Case File Number PLN15179-R02

<b>Location:</b>	1900-1944 Broadway (APNs: 008-0638-005-00; 008-0638-006-03; 008-0638-007-10). (See map on reverse)
<b>Proposal:</b>	Final design review of a planned 38-story building (plus rooftop amenities) with 452 residential units and approximately 96,300 square feet of office and retail space. The project also includes reconditioning an existing four-story, historically-rated (Cb+1+) building and demolishing a one-story commercial building that has no historic rating.
<b>Applicant/Owner:</b>	Seth Hamalian, 19 <sup>th</sup> and Bway Associates, LLC
<b>Planning Permits Required:</b>	NA. Project approved at the June 20, 2018, Planning Commission meeting. Final design review in response to Planning Commission direction.
<b>General Plan:</b>	Central Business District
<b>Zoning:</b>	CBD-P Central Business District Pedestrian Retail Commercial Zone and CBD-C Central Business District General Commercial Zone. Height Area 7 (no height limit).

# CITY OF OAKLAND PLANNING COMMISSION

# **1900 Broadway**

## **DRC COMMENTS**

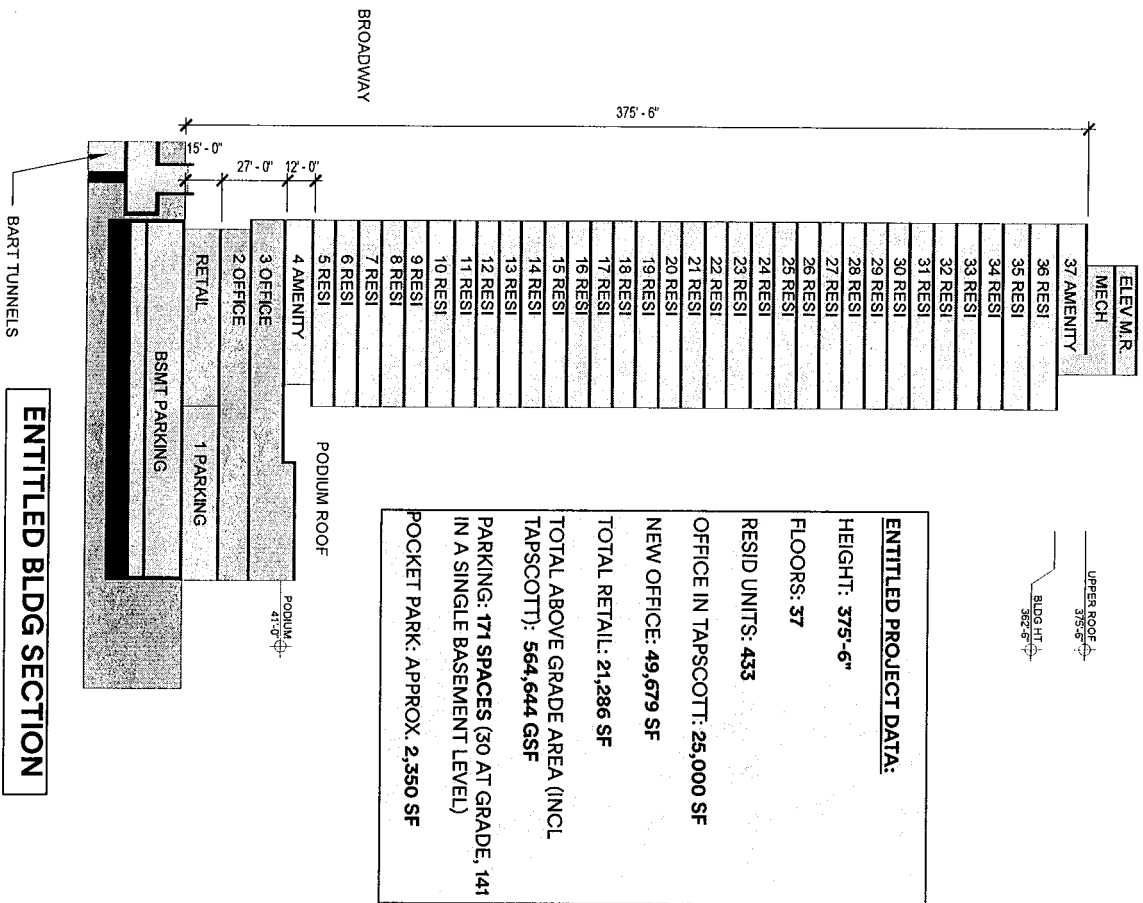
- **CHAMPAGNE PATTERN APPEARS RELENTLESS. CONSIDER REDUCING AND REFINING PATTERN**
- **DEVELOP THE PATTERN AT THE PODIUM SO THAT THERE IS A STRONGER RELATIONSHIP BETWEEN THE PODIUM AND THE TAPSCOTT BUILDING**

1. Comment brought up concerning the amount of the yellow/champagne color on the facade, that amount of the material was too much, and used "relentlessly".

2. Comment that there needs to be a stronger break to distinguish the building base/podium from the tower. The pattern of the curtain wall aligned with the Tapscott Building needs to change from the tower pattern vertically to create a more distinguishable horizontal.

**RESPONSE:** The thickness of the champagne bands at the typical tower floors has been reduced by nearly 50% by reducing the width of the elements, and stopping them short of building corners to allow for more vision glass. As a result, they no longer read as strong visual elements which immediately catch the eye, but more as complimentary pieces creating a rhythmic pattern.

**RESPONSE:** The difference in the visual patterning of the glass facade between floors 4 and 5, which coincides with the top of the Tapscott, has been accentuated. The amount of champagne panel in the base has been reduced, and completely offset from the curtain wall pattern above. This creates a more distinctive break from the tower when taken in tandem with the difference in lighting between office/retail/amenity spaces below the break and residential units above.

### ISSUES BROUGHT UP DURING DRC COMMITTEE HEARING, 2018.02.28:

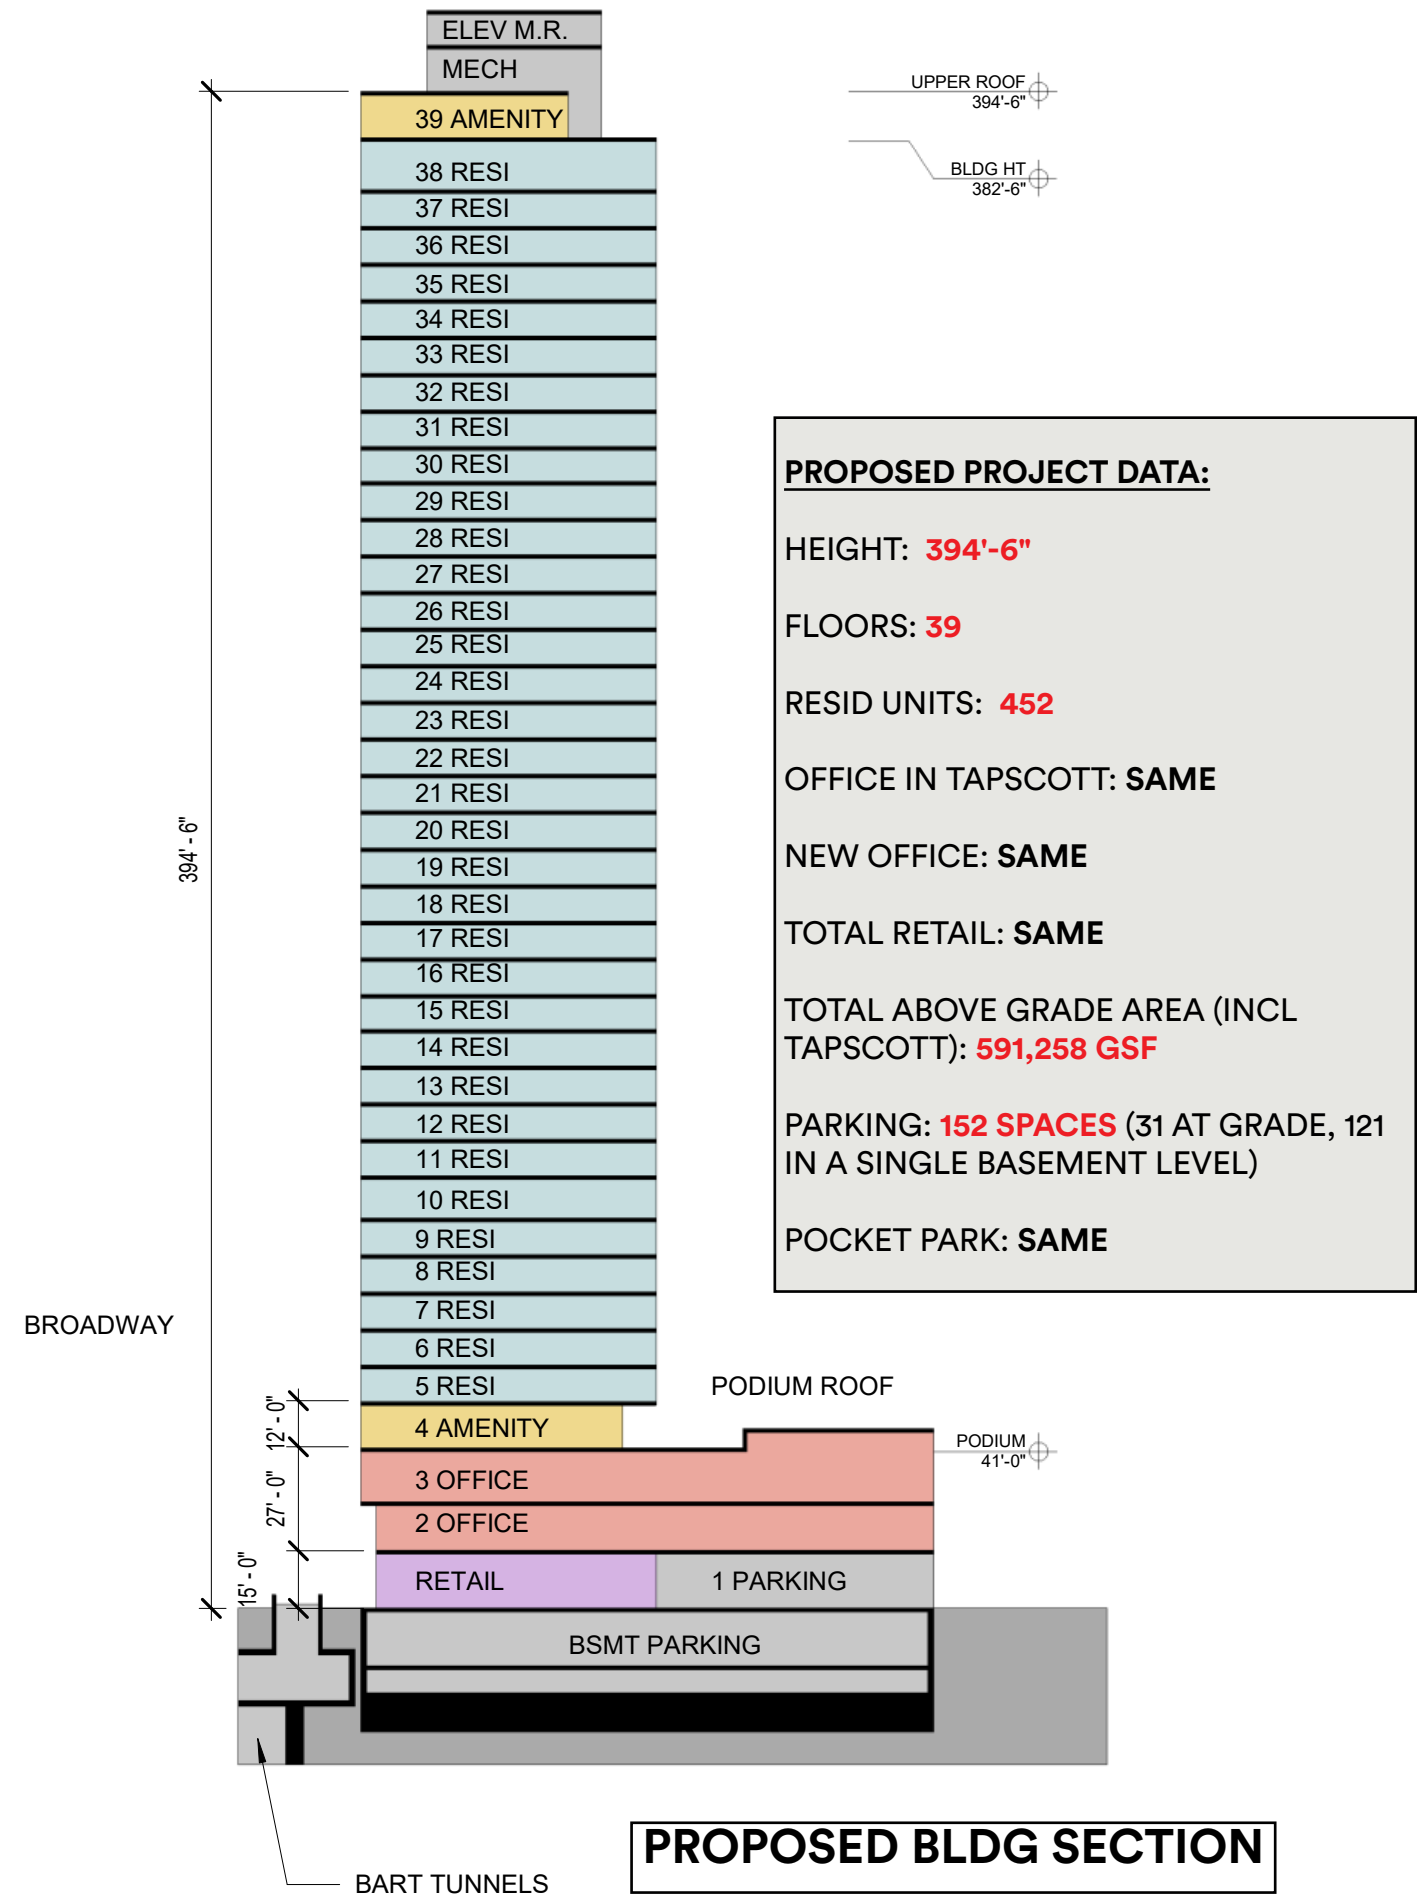
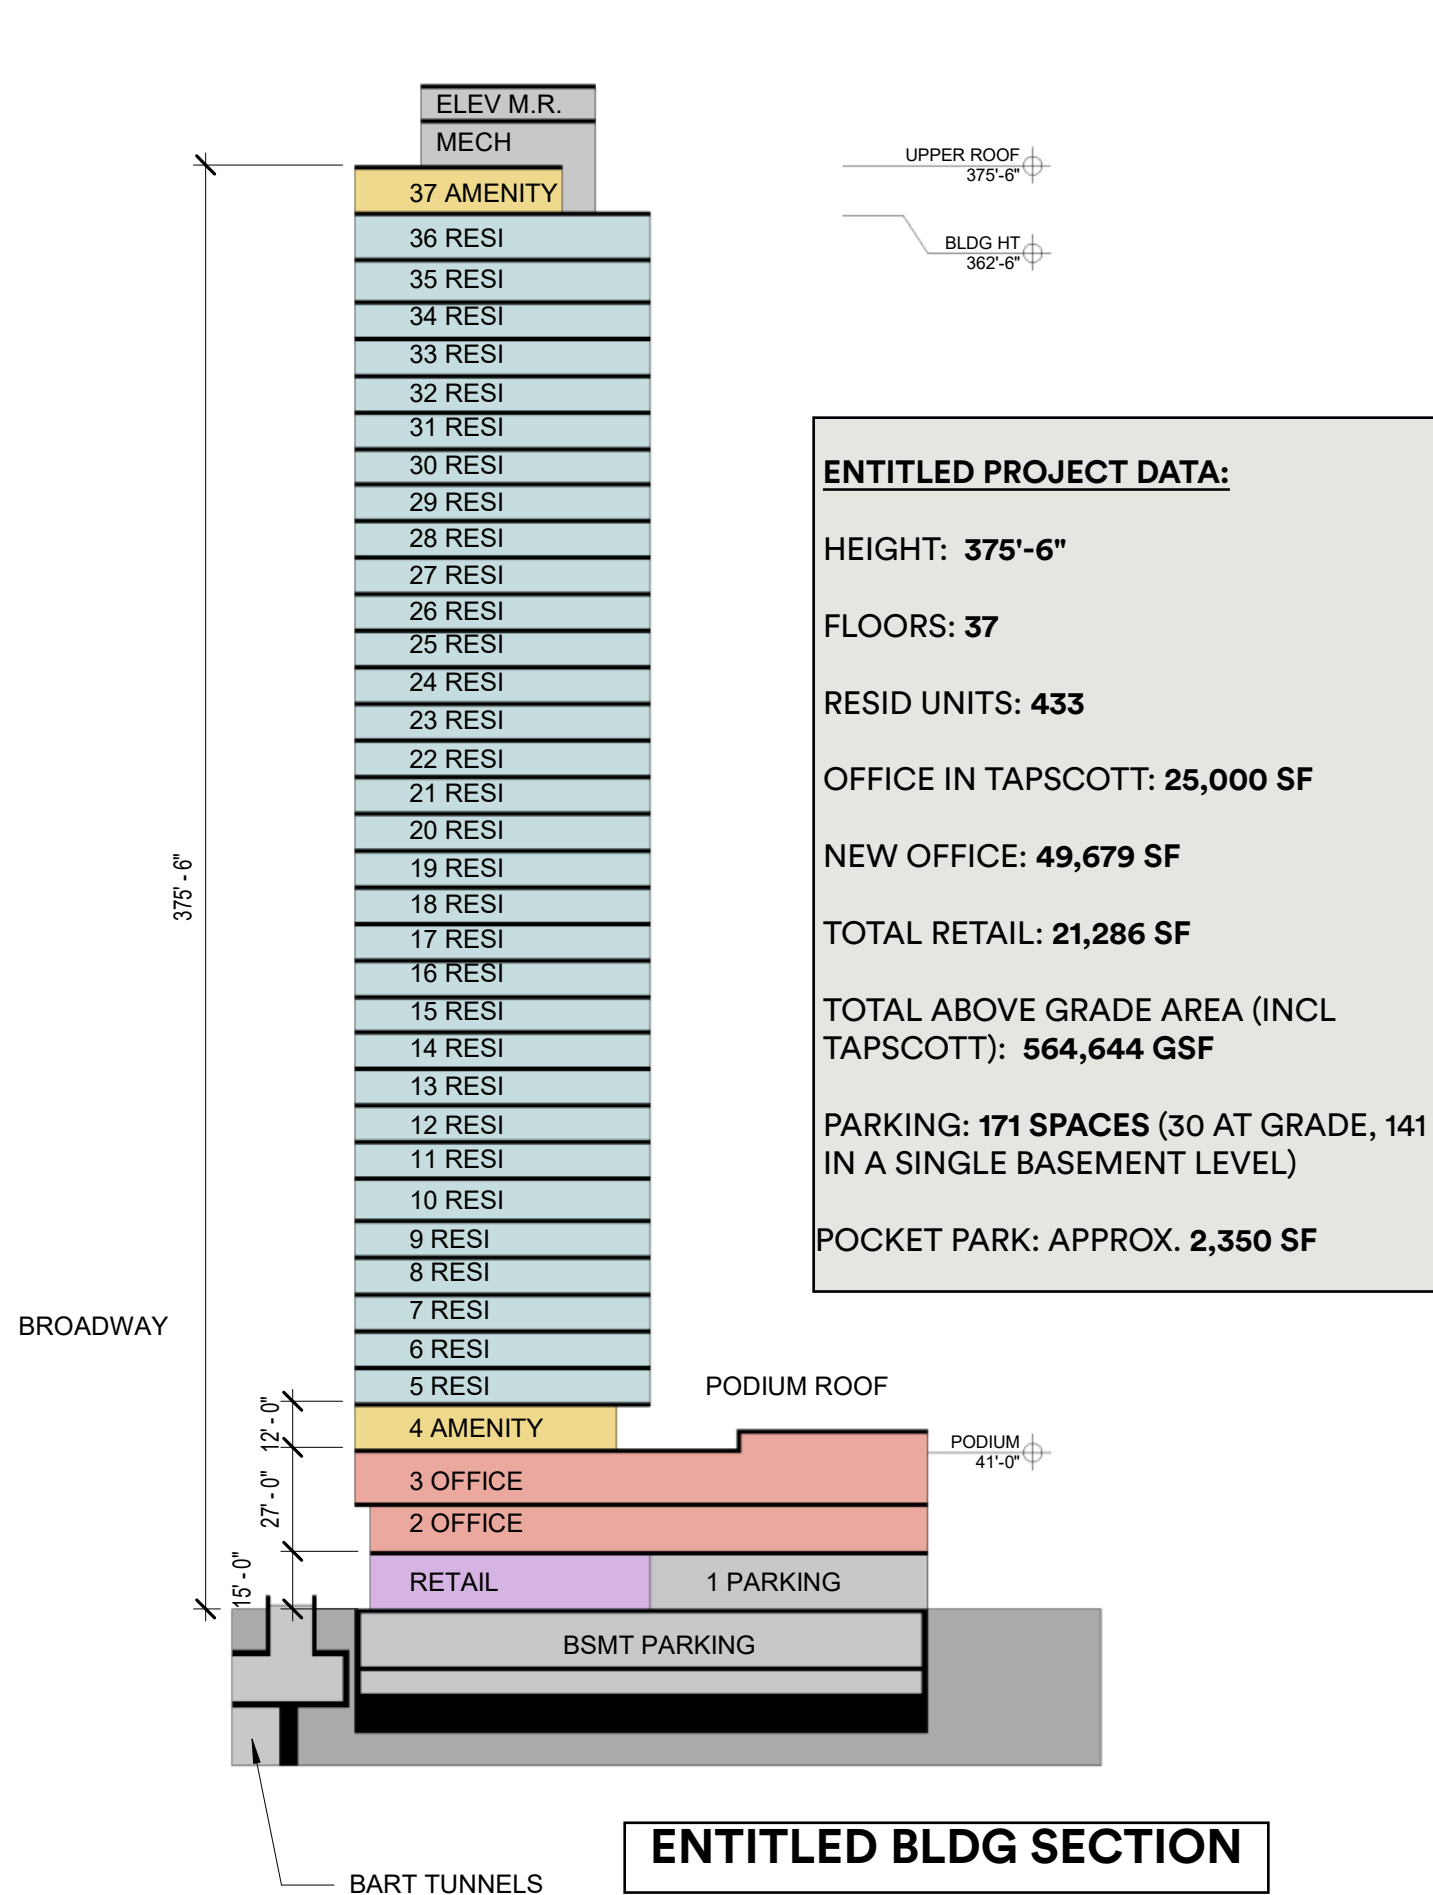
1. Comment brought up concerning the amount of the yellow/champagne color on the facade, that amount of the material was too much, and used "relentlessly".

**RESPONSE:** The thickness of the champagne bands at the typical tower floors has been reduced by nearly 50% by reducing the width of the elements, and stopping them short of building corners to allow for more vision glass. As a result, they no longer read as strong visual elements which immediately catch the eye, but more as complimentary pieces creating a rhythmic pattern.
